BLE Mesh Gateway IR AC Controller

TITLE Table of Content			
Qmax Systems India Pvt. Ltd. 310-2A, Rukmani Nagar 4th Street, Poonamallee Chennai -600056 www.qmaxsys.com		SIZE A3	DRAWING NO P01230GW1
SCALE NONE		RELEASE DATE Thursday, February 01, 2024	SHEET 2 OF 9

TITLE		
Microcontroller & Sensors		
SIZE	DRAWING NO	REV
A3	P01230GW1	1.0
SCALE	RELEASE DATE	SHEET
NONE	Thursday, February 01, 2024	5 OF 9

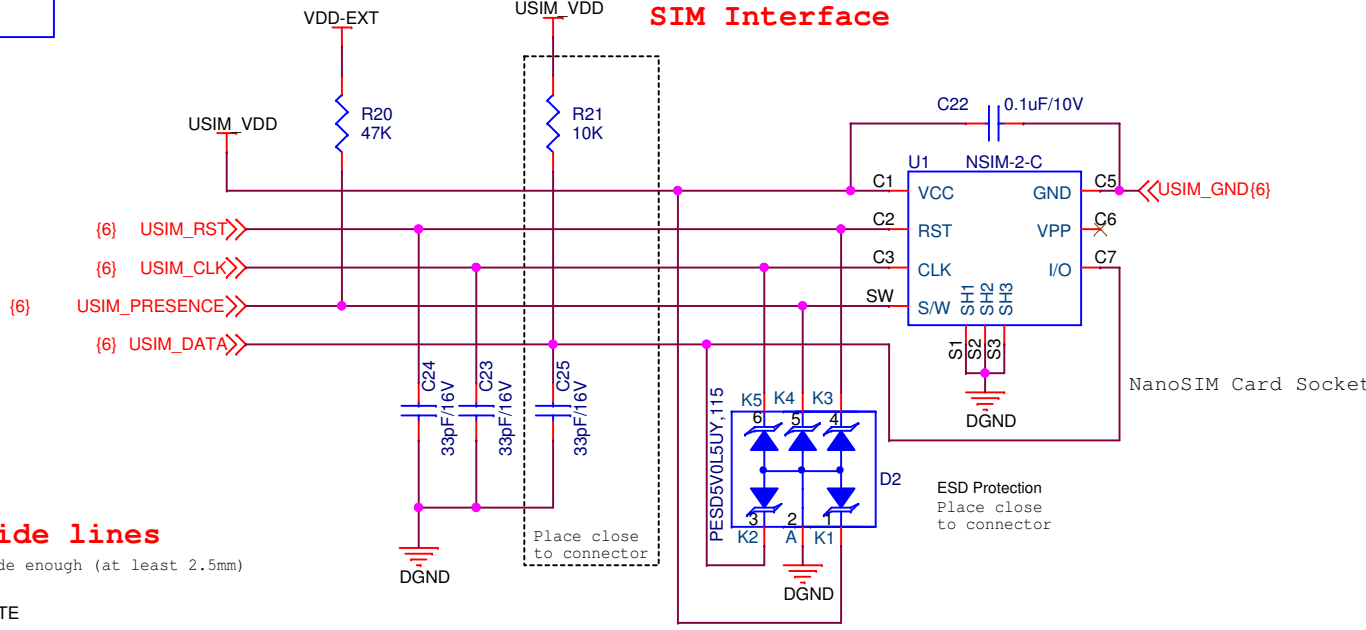
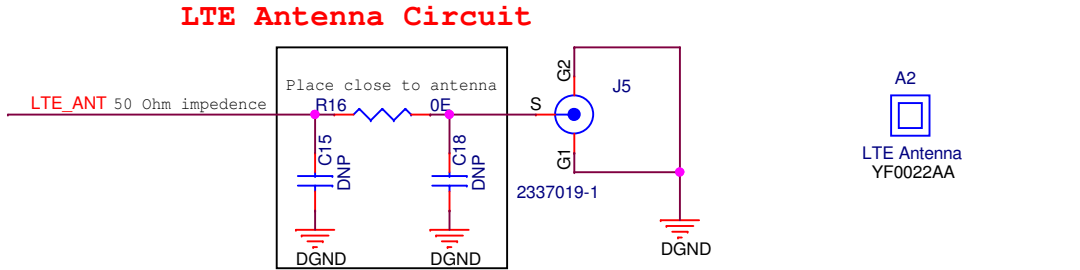
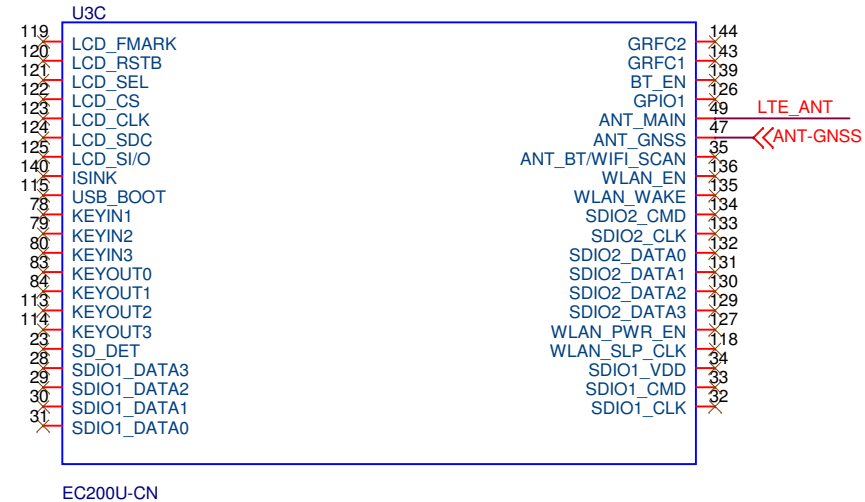
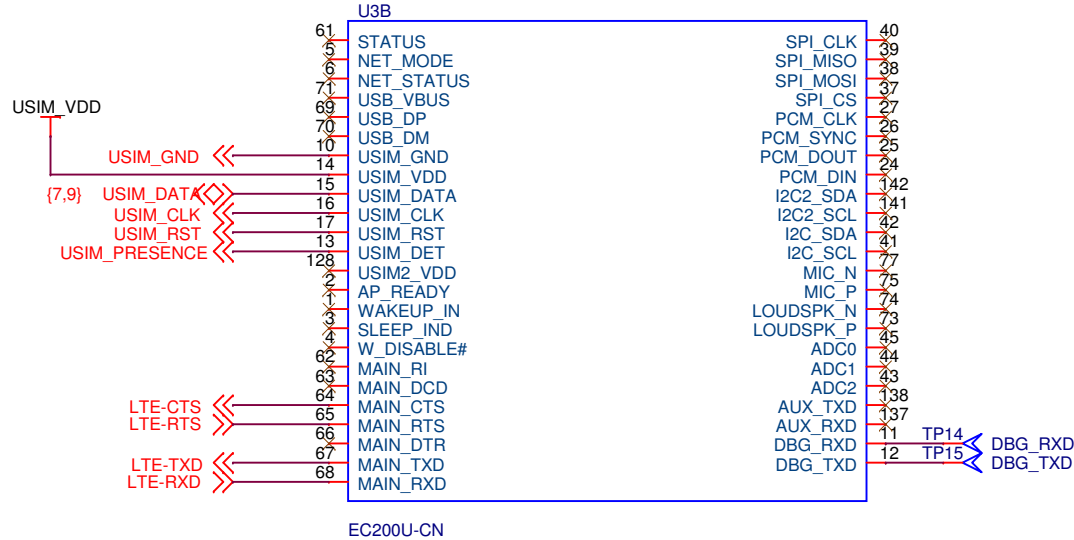
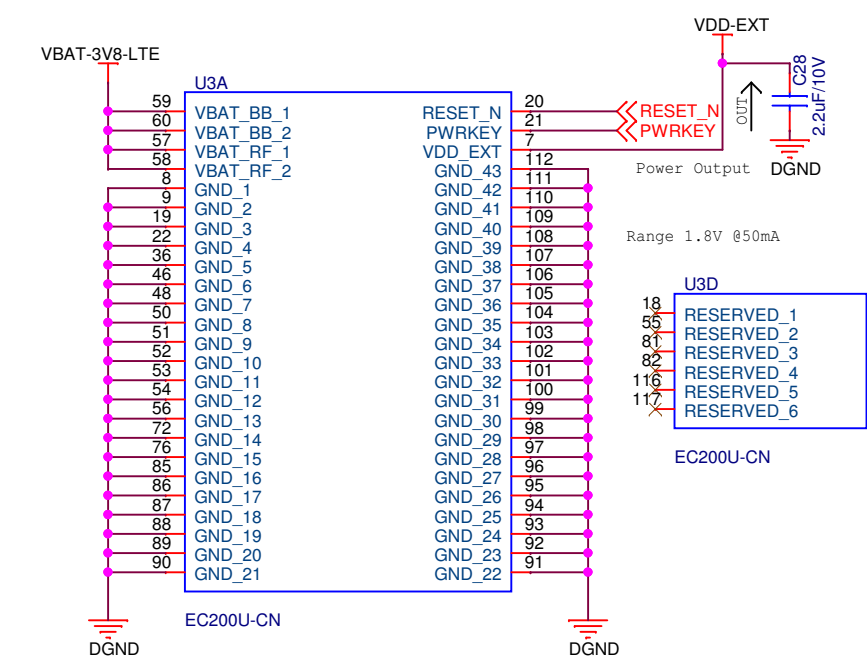
TEMP-ALERT, is only 1.8V capable pin- need to be changed
TEMP-ADC-IN(IO47 is not ADC pin) pins need to be changed
C20-DNP, R53-1K
